## City of Mississauga Department Comments

File(s): A575.22 Ward: 7

The applicant requests the Committee to approve a minor variance to allow for a detached garage proposing an interior yard setback of 0.90m (approx. 2.95ft) whereas By-law 0225-2007, as amended, requires a minimum interior yard setback of 1.21m (approx. 3.97ft) in this instance.

Property Address: 3038 Franze Dr

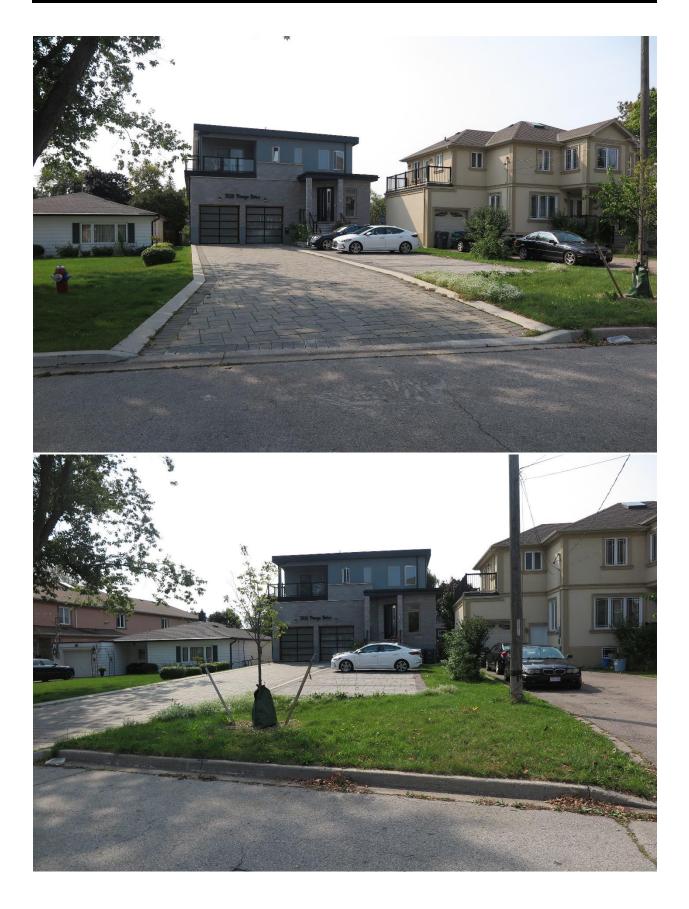
Staff note the application was deferred from the December 8<sup>th</sup>, 2022 hearing concerning the applicant's proposal to widen the existing driveway. Planning staff was not in support of the given proposal at that time. Staff note through site visits and the subsequent pictures provided that the driveway has been widened and is being utilized for parking of motor vehicles. Planning staff are not in support of the driveway in its existing condition.

The proposed variance relates to a side yard setback to the proposed detached garage to be located in the front yard. While Planning staff are not in a position to interpret the zoning by-law, staff note that additional variances appear to be required for the location of the detached garage in the front yard between the front wall of the dwelling and front lot line and maximum number of garages permitted per lot. Planning staff further note that if the correct variances were included with the application submission, staff would not be supportive of the proposal. As mentioned above, the second garage would not be consistent with the established neighbourhood context or planned character of the area. Additionally, the zoning by-law specifically prohibits detached garages from being located between the front wall of the dwelling and the front lot line. Given the City's decision to prevent detached garages in front yard areas, as well as limiting properties to only having one garage per site, staff are of the opinion that the proposal does not maintain the intent and purpose of the zoning by-law. Staff have no concerns with the proposed setback, however staff cannot support the application as it is because of the existing garage and the proposed location of the additional garage.

Planning staff are of the opinion that the proposal is not minor in nature and does not represent orderly development of the subject property.

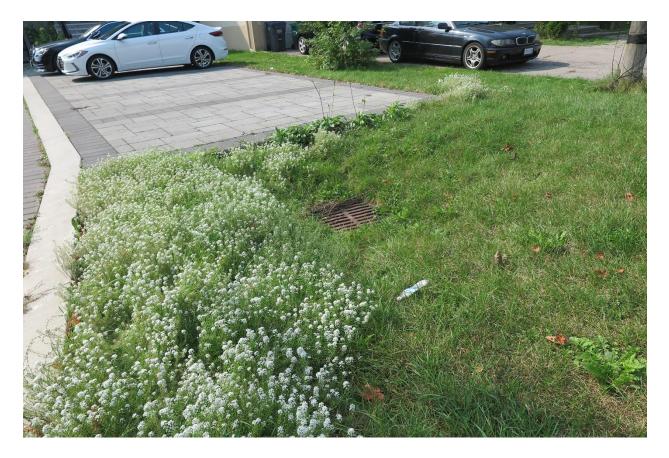
It should be noted that there is an existing catch basin within the municipal boulevard in front of this dwelling which is not to be impacted by the proposed detached garage or proposed landscaping.
